SERVICE BULLETIN

SERVICE BULLETIN		No.: MSB-99E13-501	
		Date: 1999-11-15	<Model> (EC) PAJERO SPORT (K9)
Subject: CORRECTION OF CONNECTOR NOS.		<M/Y> 99-10	
Group: FUEL	Draft No.: 99SY521640		
CORRECTION	INTERNATIONAL CAR ADMINISTRATION OFFICE	 T.NITTA - PROJECT LEADER AFTER SALES SERVICE & CS PROMOTION

SERVICE BULLETIN		No.: MSB-99E35-502	
		Date: 1999-09-30	<Model> (EC) PAJERO SPORT (K9)
Subject: CORRECTION TO SHAPE OF LSPV AND TO SPRING SUPPORT INSTALLATION		<M/Y> 99-10	
Group: SERVICE BRAKE	Draft No.: 99SY040216 (EC) MONTERO SPORT		
CORRECTION	OVERSEAS SERVICE DEPT	 T. NITTA - VICE GENERAL MANAGER QUALITY INFORMATION ANALYSIS

SERVICE BULLETIN		No.: MSB-99E55-001	
		Date: 1999-07-30	<Model> (EC) PAJERO SPORT <M/Y> 99-10 (EC) MONTERO SPORT
Subject:	CHANGE IN RESISTANCE VALUE OF RESISTOR		
Group:	HEATER, A/C & VENTILATION	Draft No.: 99SY121514	
INFORMATION	OVERSEAS SERVICE DEPT	 T.NITTA - VICE GENERAL MANAGER QUALITY INFORMATION ANALYSIS

**LOAD SENSING SPRING LENGHT CHECK AND ADJUSTMENT**

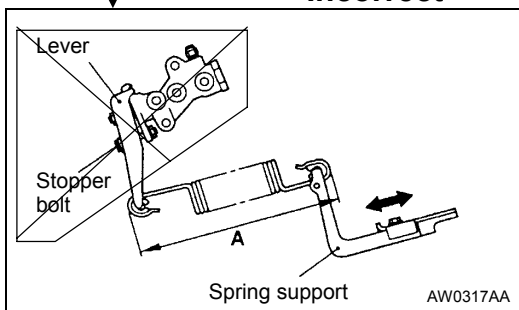
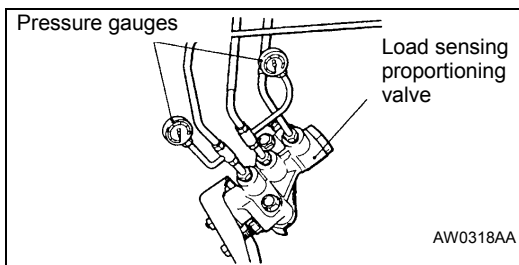
Correction has been made to the shape of the load sensing proportioning valve (LSPV) and to the spring support installation procedure.

<Correct>

<Incorrect>

vehicle is on the ground in an unladen condition,

Standard value (A): 164 - 168 mm

►A◄ SPRING SUPPORT INSTALLATION

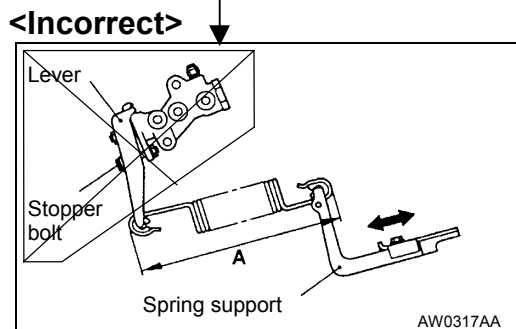
<Correct>

<Incorrect>

Vehicle is on the ground in an unladen condition,

Standard value (A): 164 - 168 mm

PARKING BRAKE LEVER STROKE CHECK

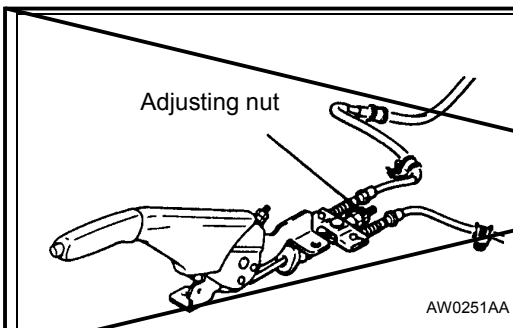
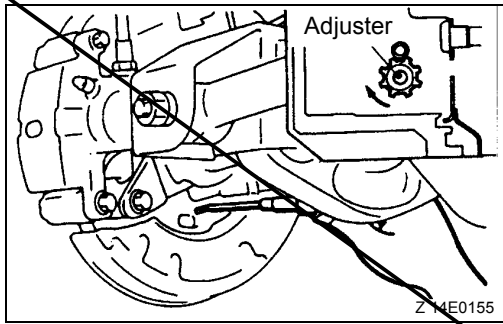
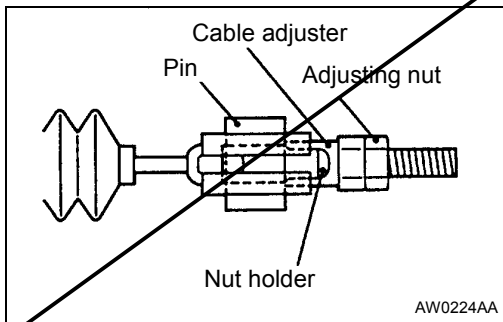
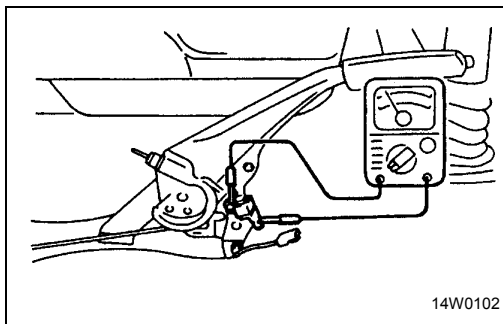
- (2) Lever Stroke Adjustment **<Deleted>**
~~<Adjustment procedure (from passenger compartment)>~~

<Deleted>**<Adjustment procedure (from under the vehicle)>**

PARKING BRAKE LEVER

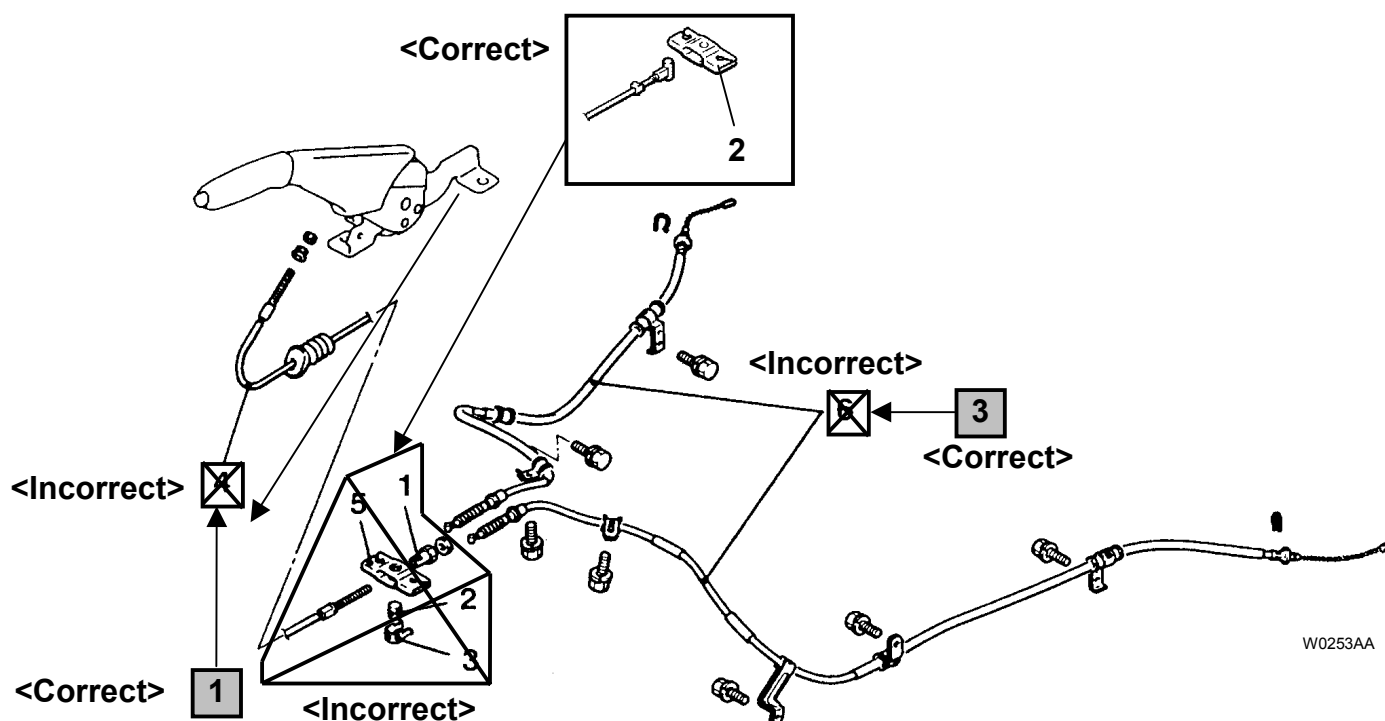
<Incorrect>

<Correct>

- Front parking brake cable
- Cable equalizer
- Parking brake cable

Terminal Voltage Check Chart

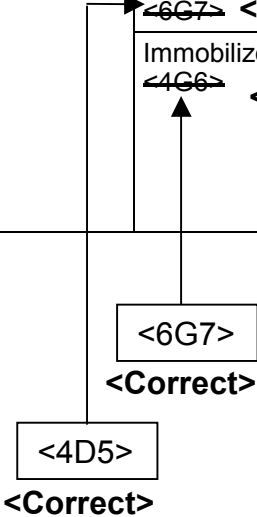
Terminal No.	Signal	Checking requirements	Terminal voltage
3	Immobilizer-ECU earth	Always	0 V
6	Ignition switch-IG <4D5>	Ignition switch: OFF	0 V
		Ignition switch: ON	System voltage
7	Immobilizer-ECU power supply	Always	System voltage
	<6G7> <Incorrect>		
	Immobilizer-ECU power supply	Ignition switch: OFF or approx. 5 or more seconds after switch has been turned from ON to OFF	0 V
	<4G6> <Incorrect>		
		Ignition switch: ON or within approx. 5 seconds after switch has been turned from ON to OFF	System voltage

RESISTOR CHECK

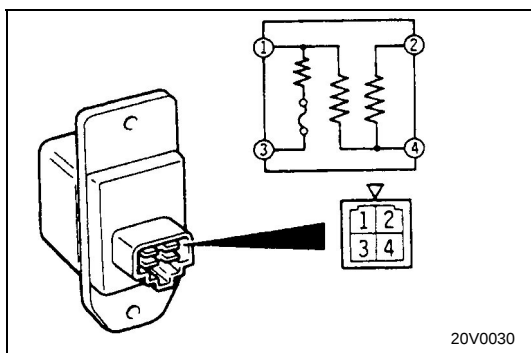
In order to modify the air flow characteristics of the blower fan, the standard resistance value of the resistor has been changed from 0.68 • to 0.37 • between terminals 3 and 1.

<New>

<Old>

**0.68 <Up to the beginning of February 1999>
0.37 <From the middle of February 1999>**
